# ASSESSMENT REPORT

## Section 75W Modification – Moolarben Coal Mine

Figure 3: Proposed Layout of Surface Infrastructure

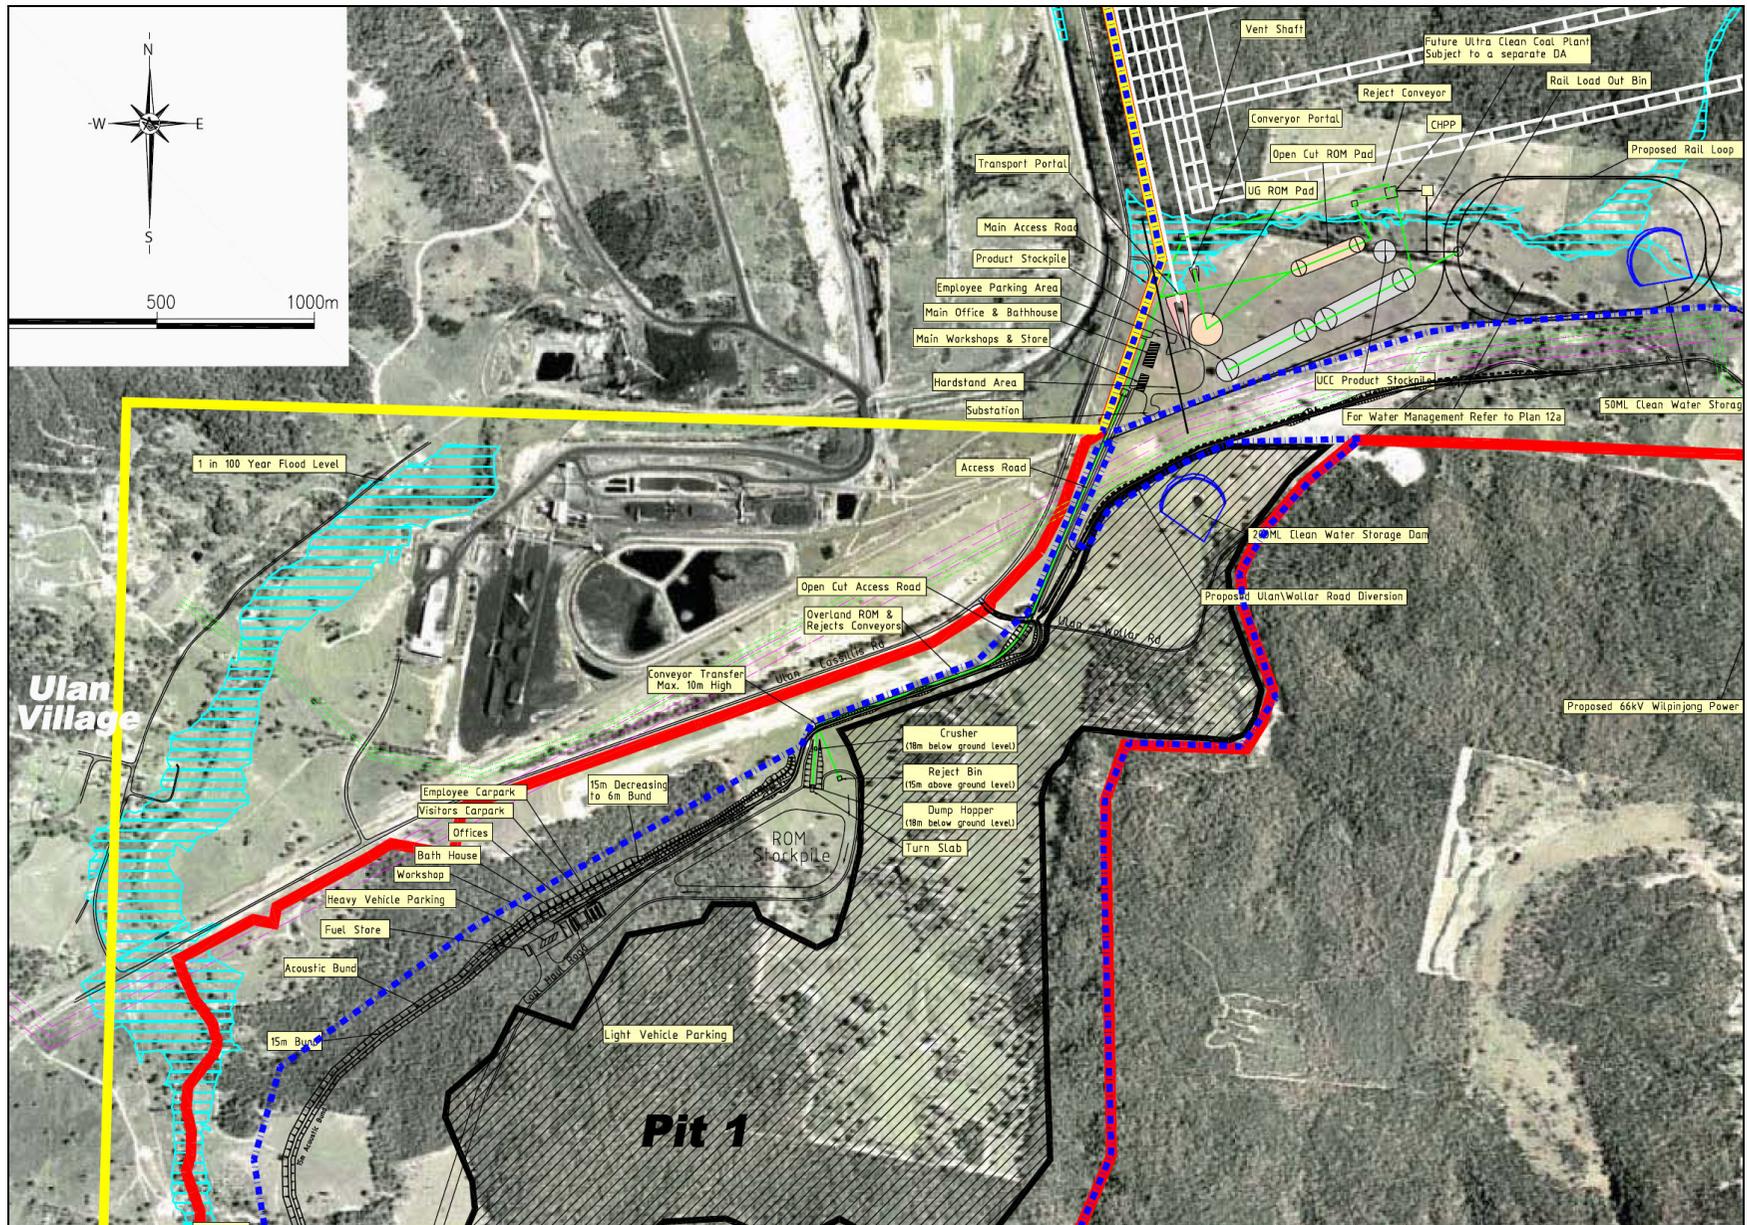
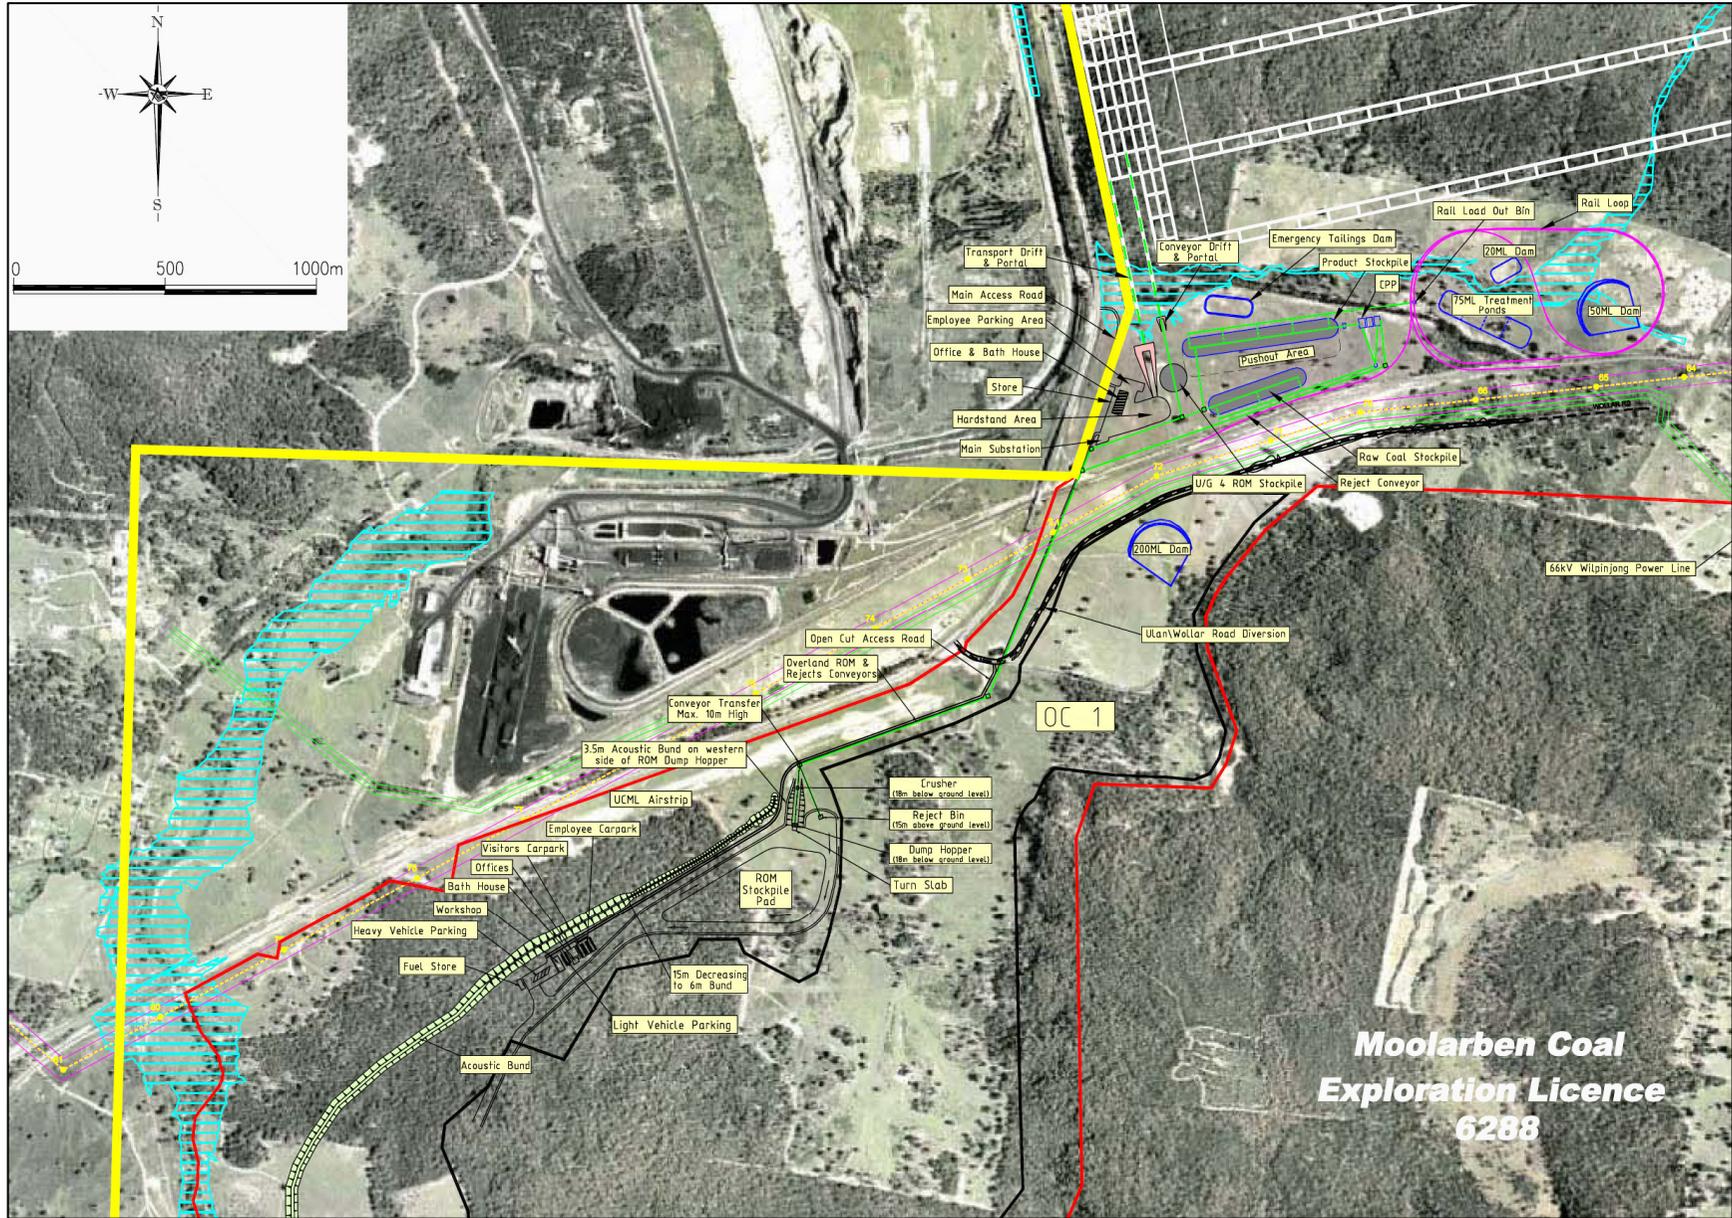
It is proposed to rearrange some surface infrastructure to provide upfront construction savings and improve operational efficiencies throughout the life of the project. These proposed changes to the surface infrastructure are summarised in Table 1 and depicted in Figures 2 and 3.

Infrastructure	Proposed Change
Coal Processing Plant (CPP)	The coal processing plant to be relocated approximately 350m to the south.
Emergency Tailings Dam	The emergency tailings dam to be relocated approximately 250m to the southwest.
Transfer Stations and Conveyors	The transfer station for reject from the CPP to be relocated 700m south. Conveyors and other associated transfer stations to be relocated but to remain within original infrastructure footprint. No conveyors to be located north of or crossing Bora Creek.
Surge Bin	The surge bin feeding the CPP to be relocated 450m south.

<b>Infrastructure</b>	<b>Proposed Change</b>
Rail Loop Configuration	"Figure 8" type rail loop constructed as opposed to a "conventional" rail loop.
Rail Load Out Bin	No change
Raw Coal Stockpile	The raw coal stockpile to be moved approximately 300m to the south, effectively "swapping" locations with the approved product coal stockpile.
Product Coal Stockpile	The product coal stockpile to be moved approximately 50m to the north, effectively "swapping" locations with the approved raw coal stockpile.
Underground No. 4 Run-of-Mine (ROM) Pad	No change
Underground No. 4 Transport Portal	No change
Underground No. 4 Conveyor Portal	No change
Underground No. 4 Conveyor Arrangement	The conveyors and transfer stations associated with Underground No.4 to be relocated to address the change in location of the raw coal stockpile.
Groundwater Treatment Ponds	Groundwater treatment ponds are essentially in the same location, taking into account the rail loop changes, however the configuration of these has changed to reflect a single treatment pond with internal barriers.

20ML Water Storage Dam	The 20ML storage dam to be moved 230m to the north-west in line with the amendments to the rail loop and treatment pond configuration.
Office and Bathhouse, Employee Parking, Store, Main Substation and Hardstand Area	Minor change to layout original surface footprint to reflect change in conveyor arrangements.
Main Access Road	No change
Open Cut Access Road	No change
Overland Run-of-Mine (ROM) and Rejects Conveyor	No change
Acoustic Bund	No change
Open Cut 1 Offices, Bath House, Employee and Visitor Car Parking, Light Vehicle Parking, Heavy Vehicle Parking, Workshop and Fuel Store Area	No change
Run-of-Mine (ROM) Stockpile Pad	No change

<b>Issue</b>	<b>Features/Impacts</b>	<b>Conclusion/Mitigating Factors</b>
Noise	Potential impacts from noise due to changed acoustics.	<ul style="list-style-type: none"> <li>▪ A review of noise impacts from the modification was undertaken by Spectrum Acoustics.</li> <li>▪ The review found the proposed rearrangement of infrastructure would not result in a measureable change to the noise levels predicted for Stage 1 of the MCP.</li> </ul>
Air Quality	Potential impacts from dust	<ul style="list-style-type: none"> <li>▪ A review of air quality impacts was conducted by Holmes Air Sciences.</li> <li>▪ The review found the proposed rearrangement of infrastructure would not alter the findings of the air quality assessment approved for Stage 1.</li> </ul>
Flora, Fauna and Aquatic Ecology	Potential impacts to flora, fauna and aquatic ecology	<ul style="list-style-type: none"> <li>▪ Bora Creek riparian vegetation is of high ecological value being made up of White Box, Yellow Box and Blakely's Redgum Woodland endangered ecological community (EEC).</li> <li>▪ Relocation of Infrastructure to the south of Bora Creek would reduce impacts to the EEC and reduce the disturbance to Bora Creek.</li> </ul>

This assessment has found that the proposed relocation of infrastructure would not generate any adverse environmental impacts above and beyond those associated with the approved Stage 1 operation and in some cases would improve the outcome.

Figure 4: Current Land Ownership of "Red Hills" property and adjoining lands shown in detail

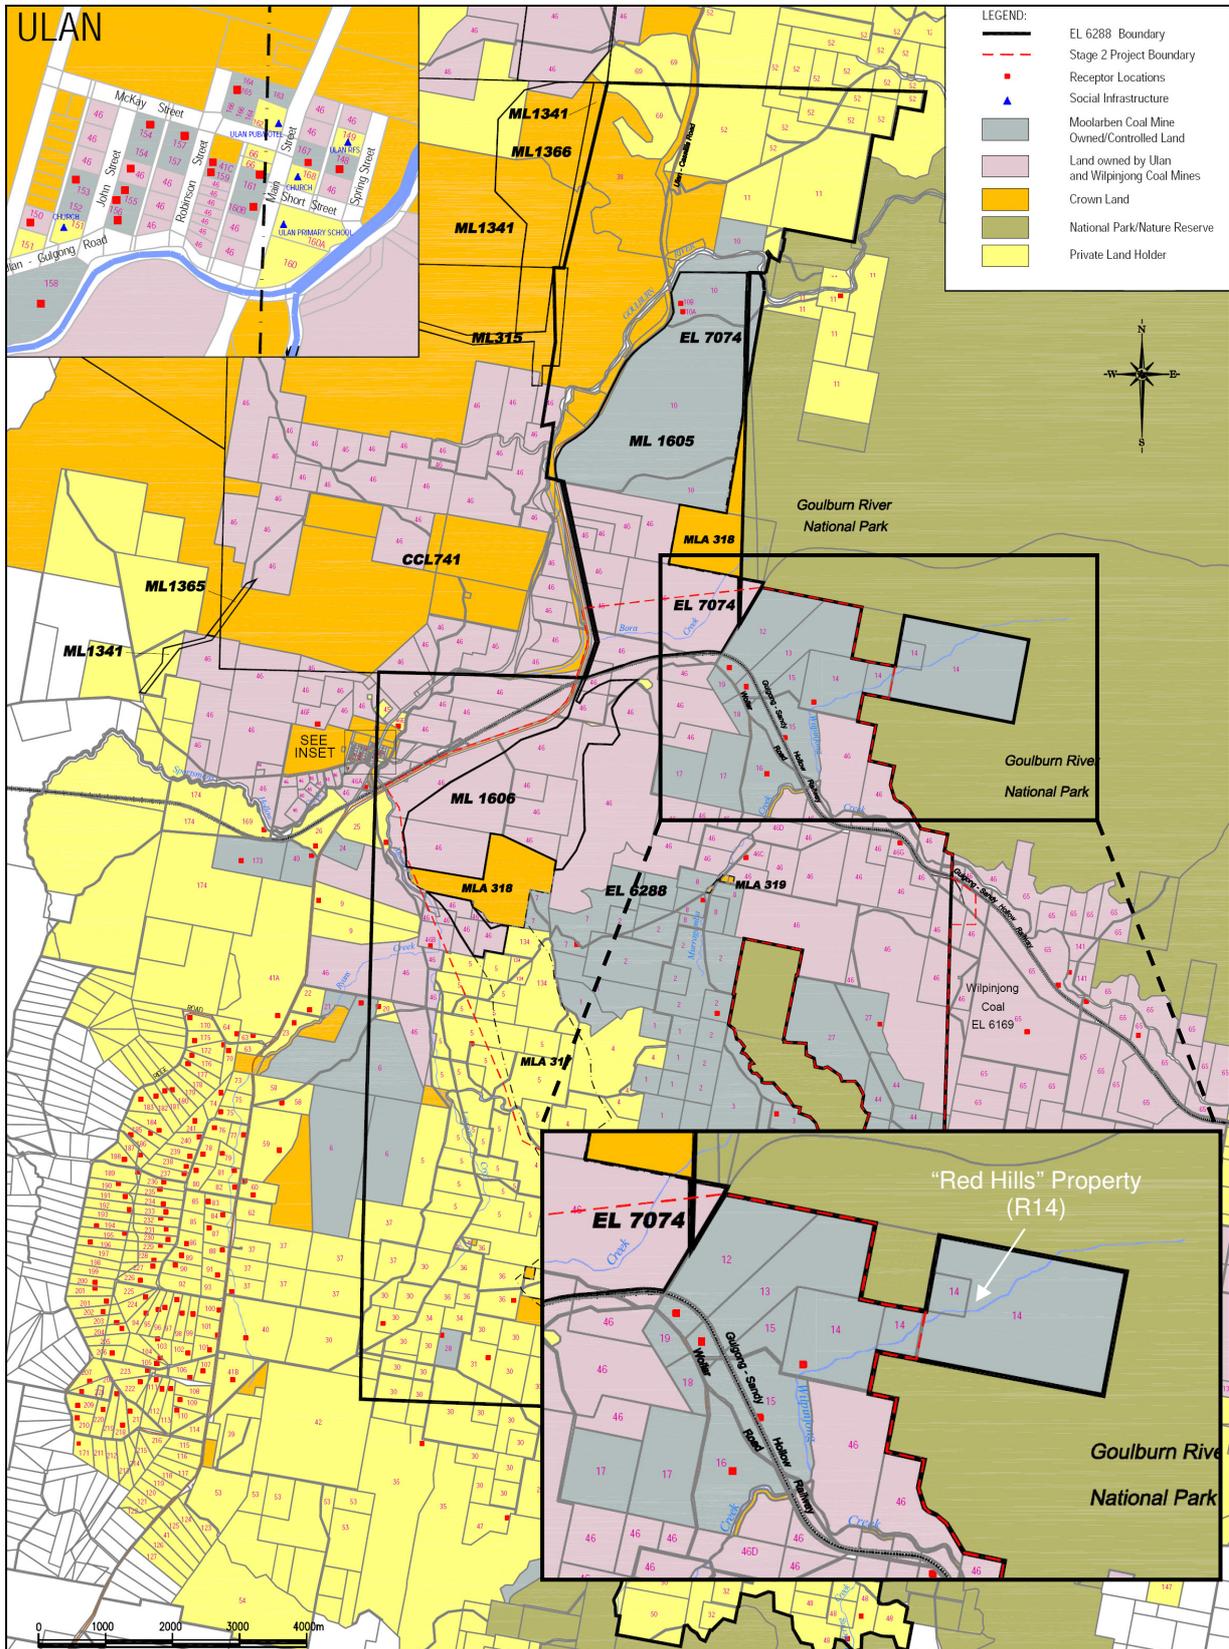
As a result, Moolarben has requested that Condition 42(b) be modified to include properties adjoining "Red Hills" (R12, R13, R15, R16, R17, R18 and R19) that have been acquired since the grant of the project approval for Stage 1 of the MMC (see Figure 4).

Notwithstanding this, the Department noted that these areas have been excluded from the area proposed for future coal extraction and, in consultation with DECC, questioned whether Moolarben intends to rely on some or all of these areas for revegetation and/or offsetting strategies associated with Stage 2 of the MCP.

In its response to submissions, Moolarben advised that revegetation areas for Stage 1 would not conflict with any possible revegetation or offset dedication associated with Stage 2. Moolarben confirmed that there is approximately 273 hectares of cleared lands available within the identified properties adjoining “Red Hills” (see Figure 6). This satisfies the 143 hectares required under Condition 42(b). Furthermore, the company confirmed that the revegetated lands would not be cleared in the future and when established would be further protected under the Native Vegetation Act 2003.

The Department has considered the issues raised in DECC’s submission, and is satisfied the need for the change to the condition of approval is warranted. Moolarben would be required to consult with DECC on the precise location of areas to be revegetated to meet the requirements of Condition 42(b).

Figure 7: Roads Specified under Condition 56 as modified

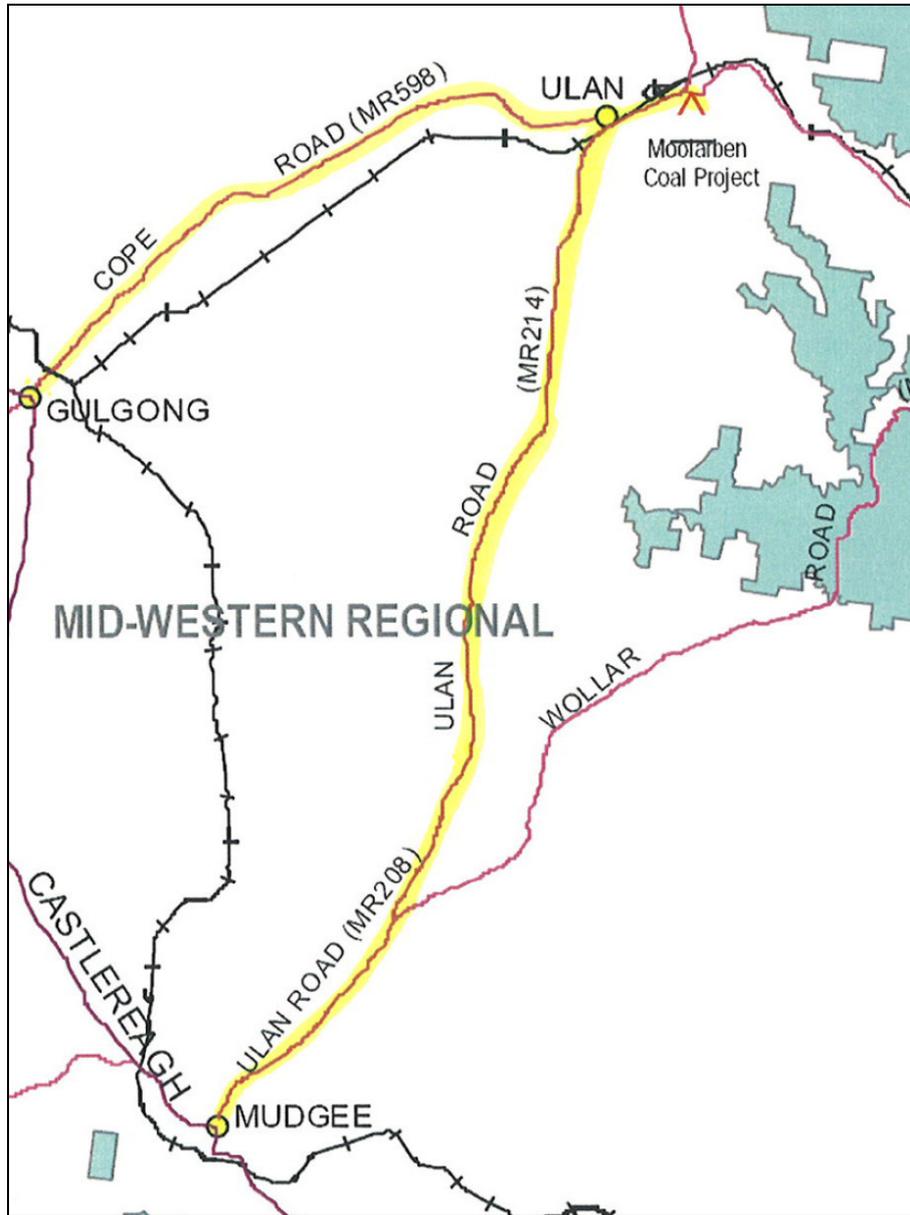
The company is seeking to modify Condition 56, Schedule 3 on the basis that Cope Road (MR 598) be included as one of the roads to be upgraded under the terms of Conditions 56 and 57 of Schedule 3. The Stage 1 MCP always envisaged that this road would be upgraded given that some workers (approximately 25%) would travel to and from the mine from Gulgong via Cope Road (see Figure 7). Accordingly, this road formed part of the planning agreement for the project.

In relation to Ulan Road, the original intent of the condition was for Moolarben to commit to the staged upgrade of this road, in consultation with WMC, from Mudgee to Ulan Village (see Figure 7). In relation to Ulan-Wollar Road, the original intent of the condition was for Moolarben to upgrade this road from the proposed mine access road for the open cut mining area, to its point of intersection with Ulan-Cassilis Road (see Figure 8).

The Department has no objection to the inclusion of Cope Road (MR 598) within Condition 56 of Schedule 3, and has also taken the opportunity to clarify the extent of responsibility for Moolarben to upgrade the Ulan-Wollar Road.
